Cabinet Member for City Services

Objections to Proposed Waiting Restrictions (Variation 8)

Appendix A – Summary of proposed restrictions, objections, letters of support and responses

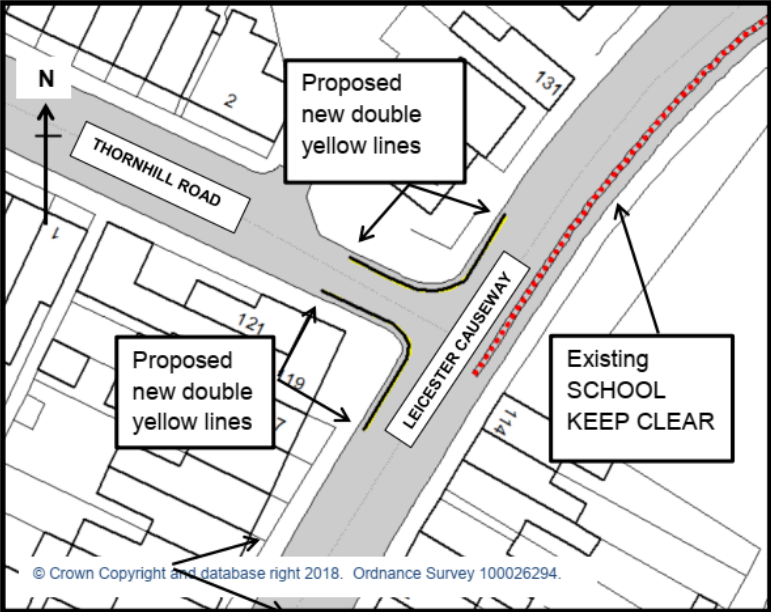
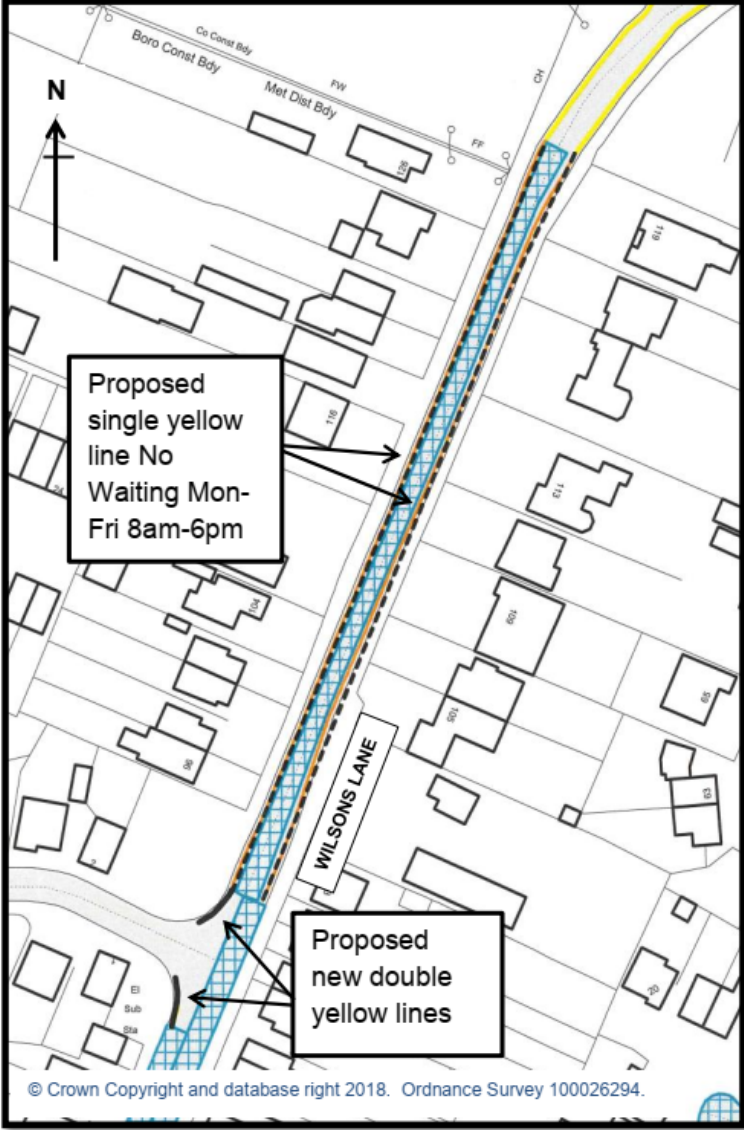
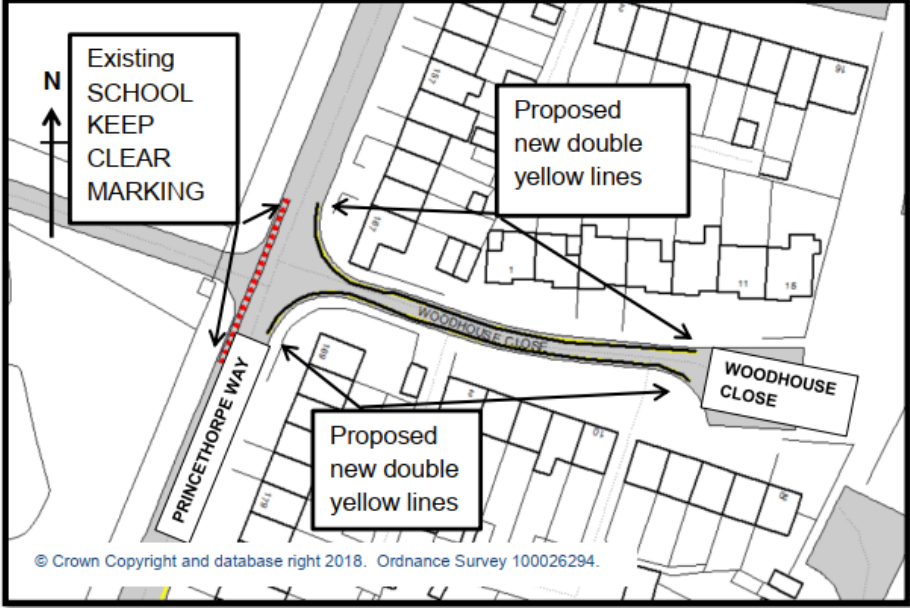
<p>The centre of Coventry has had extensive modifications to its traffic structure over the last six years, driven by the concept of shared spaces, and generally they have worked quite well. I suggest that the notions used could be applied here to retain the character of the 'village' which is actually quite nice.</p> <p>The local shopping street is one of the very few convenient and welcoming experiences in Coventry. It forms a significant part of the character of the area and makes Station Avenue a pleasant place to live.</p> <p>There is the issue of daily long-term parking for commuters who leave via the railway station. They park outside private houses and some local residents have responded by parking on the street instead of their drives out of anger and desperation. This issue could be addressed in other ways. It is not easy but settling disputes between selfish people never is. There are ways to do it and the community would gain much from solving this problem instead of turning their road into a race track by painting it with yellow lines.</p> <p>This is a group objection from residents of Rex Close, (9 households listed) Our objections are as follows -</p> <ol style="list-style-type: none"> 1. The plan does not address the problem of the traffic congestion or why the upsurge in the parking on Station Ave has happened, it simply moves the problem of parking to the even numbers of Station Ave and Rex Close, causing safety and access concerns. 2. Enforcement of the proposal. We are well aware of the abuse of cars on the double yellow lines recently installed in Rex Close -access to the close has been denied due to such parking on several occasions in the last year. 3. This proposal restricts even further access to local shops - the chip shop on Station Ave reports a drastic fall in customers, and the hair salon two doors down is now only open three days a week. There are further stories too numerous to place here. If these facilities close, are we as council tax payers going to see a cut in the local monthly rate? <p>The restriction of parking in the Bell Pub grounds, people working at the packaging plant on the old Peugeot site leaving their cars on Station Ave and Rex Close all day, railway passengers facing restricted parking at Tile Hill Station, and last and certainly not least - the doctors surgery, which is always the elephant in the room when rogue parking on Station Ave and Rex Close is discussed.</p>

<p>Objections 29-32</p>	<p>We [Federation of Small Businesses] would like to respond on behalf of the small businesses and our members that could potentially be impacted by this [proposal]. We understand that this is a response to safety concerns and access issues raised by local residents. While visibility and road safety are of paramount importance we would like to raise awareness of the potential impact that the introduction of the parking measures could have on the number of local small businesses that operate on this road. We understand there are around five local small businesses, employing a number of people that could be affected by these proposals which could result in reduced footfall and lack of access.</p> <p>One of these businesses Tile Hill Footcare, is the longest established podiatry practice in Coventry having been in operation for over 30 years. During this time it has built up a local client base and has overseen an increased in demand, with the business now open for appointments five days a week. The business provides a vital health service for local residents, many of whom will be elderly or have mobility issues, and therefore would benefit from close access to the business when attending their appointments. Client appointments generally last between 30 minutes to 1 hour. There is concern that installing double yellow lines and therefore restricting access, could be damaging to the local businesses and in the case of this particular business result in many of these clients elsewhere across the City, therefore increasing travel distances.</p> <p>We also believe that a review of time restrictions of existing on-street parking, rather than the introduction of double yellow lines would also be effective for the local businesses.</p>

<p>For example, provision of a limited number of spaces with time restrictions of 1 hour may be sufficient for consumers and clients of the local businesses impacted. This will help encourage and provide sufficient flexibility for shoppers who visit these businesses to 'pop-in and out'</p> <p>We're disappointed to here the news of double yellow lines as we feel this will actually cause even more damage to not only our business but the businesses around us. Ever since the car park at the Bell Inn has been changed to a pay and display it has hit our business hard and we have lost a lot of trade due to our customers now not having somewhere to park. Because of the car park having changed to a pay and display it does mean that more people are parking their cars on the road either side and leaving them there for the day - clearly to walk down to the train station.</p> <p>What we wanted to request from the council was a lay-by at the front of the row of shops on station avenue. The businesses start from the chemist (Mistry pharmacy) to the chiropodist (Tile hill footcare & podiatry). With a lay-by installed it would give customers for all of the businesses a place to park. We feel this would benefit us greatly.</p> <p>I appreciate the need for some form of waiting restrictions along Station Avenue on the grounds of safety and allowing residents access to their houses. However, the main consequence will be that residents and commuters (a number of whom leave cars parked all day on the road) will now instead leave their cars on the even numbered side, severely blocking access to the business This will mean, in simple terms that eventually all our trade will be affected badly and long term established businesses may have to close.</p> <p>A problem which i, and the other businesses will now face is a reduction in the number of available spaces for customers . As you may be aware some commuters for the station leave their cars all day along station avenue, and block the free flow for visiting customers to park closely to the five businesses located there</p> <p>This is clearly a more complex scenario than perhaps initially perceived and we would welcome further discussion to bring about a compromise.</p> <p>This plan could close my business as myself, staff and clients have no where to park! If a fee was put onto the parking at Tile hill station, we would not have so many cars parked on Station Avenue! Is there anything that can be done to help a small business like mine?</p> <p>One other suggestion I would like to add is the idea of creating a small layby/ pull in for a strict limited waiting period. It could stretch from outside my premises (on the even numbered side) up to the beginning of, or end of the Bell Pub car park. This would make it safer for all customers and visitors to the shops and allow more road width for passing traffic.</p>

<p>Businesses – all have parking but maybe it would be better off if there was a 1 hour wait parking on the opposite side of the road (outside the Bell Inn)? At the moment train commuters and pub patrons all park there for long periods of time, this stops customer using local shops. We want to support the local businesses but we also want to be safe. Homes further down the road have expressed worries that car will park outside their homes whilst I (more than anyone) can understand their worries, the 1 hour parking should alleviate that, and I would suggest they can apply for double yellows.</p> <p>Future proof the road – Eastern Green, Cromwell Lane, Red Lane and Westwood Heath have very large developments in the pipeline– we are in the middle of a thorough fare that is already very busy at peak times this will increase substantially we need to make sure that everyone is safe.</p>
<p>Response to objection</p>	<p>There are a number of competing demands for either the provision of parking or the removal of parking on Station Avenue and the proposal was made to try to balance the competing demands of residents and businesses.</p> <p>The responses received from the residents on the western (even numbered) side of the road are requesting the introduction of double yellows and the businesses on the same side of the road are requesting the introduction of time limited parking and the creation of a layby.</p> <p>The available road space is limited and the provision of parking bays would potentially cause congestion on the road. The installation of a layby would require that adequate footway width remains for pedestrians. Funding also has to be considered and there is not sufficient budget allocated for waiting restrictions for the creation of laybys.</p> <p>Recommendation – do not install the restrictions and undertake consultation with the local residents and businesses.</p>

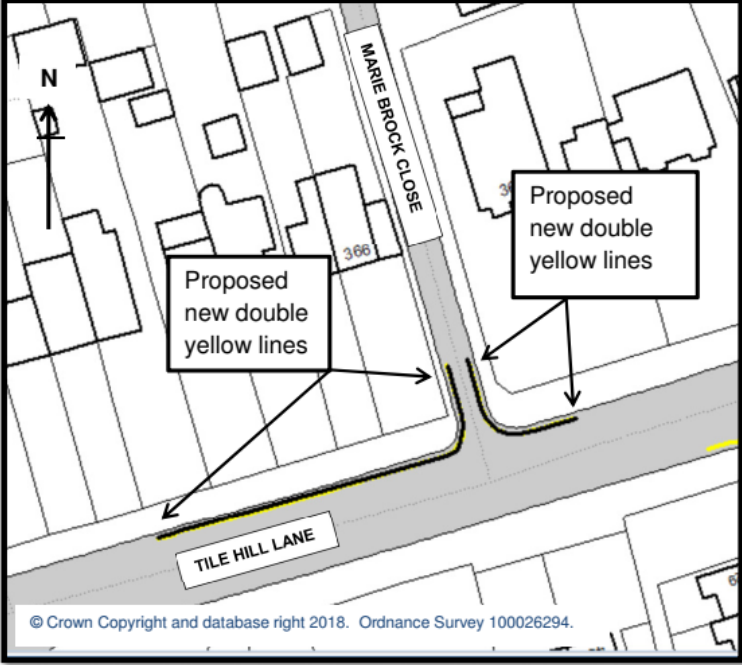
Objection 35	<p>I would like express my concern and object to this proposal. The reason is that area suffers from lack of parking space as it is and any restriction would have impact on resident's car parking. Instead, I would kindly request the council to narrow the foot path at this junction on Throhnhill Road and at the junction on Newland Road to help the vehicle circulation. I sincerely hope that the council will take this into consideration and not install the double yellow line</p>

Response to objections	<p>The double yellow lines were proposed in response to issues raised by Waste Services relating to difficulties with access. Thornhill Road is one way (heading towards Leicester Causeway), it is part of a U-shaped road arrangement consisting of Newland Road, Ena Road and Thornhill Road. The build outs that are referred to have been in place many years and would have been installed as traffic calming features, as often drivers can speed up on one way roads as they are not anticipating oncoming traffic, therefore it is not proposed to remove these features.</p> <p>The area where the double yellow lines are proposed, is an area where the road has been narrowed, therefore vehicles parked in this area will affect access, especially for larger vehicles. There are also mature trees located in this area. It is not proposed to make any changes to the alignment of the road in this area, therefore the double yellow lines have been proposed to address the access issue created by parked vehicles.</p> <p>Recommendation – install the restrictions as advertised.</p>

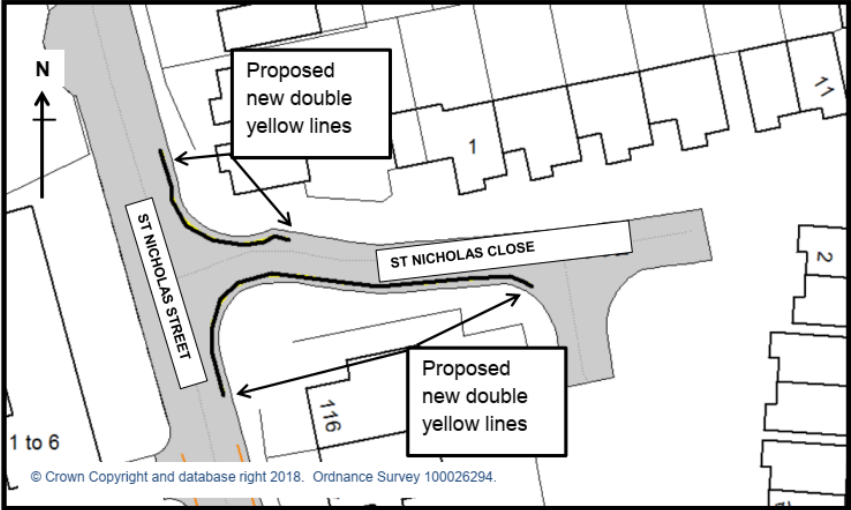
Location (Ward)	Wilsons Lane (Longford)
Original Request	Residents have raised safety concerns about commuter parking for a nearby NHS building, they advise parking is occurring on both sides of the road causing visibility and access issues.
Proposal	<p>Double yellow lines (no waiting at any time) for junction protection on Wilsons Lane each side of the junction with Old Farm Lane and 'No Waiting, Monday to Friday, 8am-6pm, from the junction northwards up to the existing double yellow lines. Outside the hours of operation of the waiting prohibition the Event Day Residents' Parking restriction will continue to operate.</p> 
Objection 36	<p>I appreciate that the council isn't obligated to provide on street parking but the proposed restriction has been the result of nearby businesses staff using the road as a car park to park whilst at work. This was a direct result of yellow lines being installed further up the road, thus moving the problem from one part of the road to another.</p> <p>The new proposed restrictions will do exactly the same, move the problem further down the road and into the cul de sac. This will result in the same problems of access for emergency vehicles, public transport and safety issues.</p> <p>I would like to propose the council consider making the road a residents permit holder zone only at all times instead of just during events. This will alleviate the issues permanently and as all residents have residents and visitor permits would not cause issues for family visitors.</p>

<p>Support 6</p>	<p>I live at xx wilsons lane and am very grateful for the new proposed parking restrictions but was wandering if there could be double yellow lines [describes area where extension of existin double yellow lines requested] as we have had numerous close calls with speeding cars from both directions . we cannot see when pulling out from the driveway [personal circumstances described] I would be very grateful if you would consider this as an option for us .</p>
<p>Response to objection</p>	<p>The proposal was made in response to residents’ concerns, the times of the restrictions proposed to try to address the commuter parking issue and lessen the impact on evening and weekend parking for residents and their visitors, as opposed to an alternative solution of installing double yellow lines. The existing event day residents’ parking restriction is to continue to operate outside of the no waiting times.</p> <p>There is the possibility that the installation of new restrictions will result in the transference of the parking problem, depending how far drivers are willing to park away and walk to their destination.</p> <p>Residents’ parking schemes are considered in areas where non-resident parking is occurring due to an attractor, such as in this instance and where there is little off-street parking. However, it appears that most residents have available off street parking. Residents’ parking schemes are introduced in response to issues raised by residents and 60% of households in a potential scheme area have to be in favour of a scheme, before it will be progressed. No other requests have been received for residents’ parking on Wilsons Lane.</p> <p>The request for additional double yellow lines could be added to the next waiting restriction review as the area highlighted is in close proximity to a bend.</p> <p>Recommendation – install the restrictions as advertised and add the request for an extension of the existing double yellow lines to the next waiting restriction review.</p>
